Access Compliance Report

Public Rights-of-Way

(Curb Ramps)

Intersection ID: 27490	Main Street: BALLANTYNE_COMMONS_PY	Cross Street: JOHNSTON_RD	Location: SE
ADA ID: 1D3F7C70432F	Ramp Type: Directional1	Initial Pass/Fail: Pass	Overall Compliance: No
Severity Score: 0			
Codes/Mitigation Info/Possible Solution		Field Measurements/Component Compliance

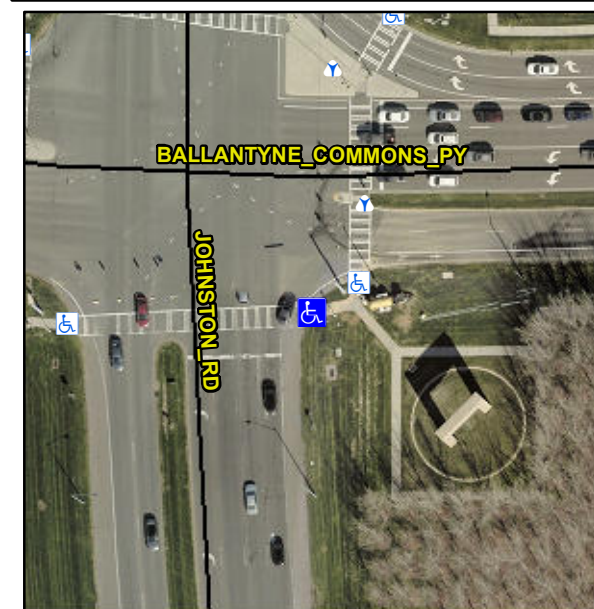
NO CURB LINE

**R304.2.2-Perp, R304.3.2-Para,
R304.5.2, R305.2, R304.5.3**

**Remove & Replace Entire Ramp.
Remove & Replace Gutter.**
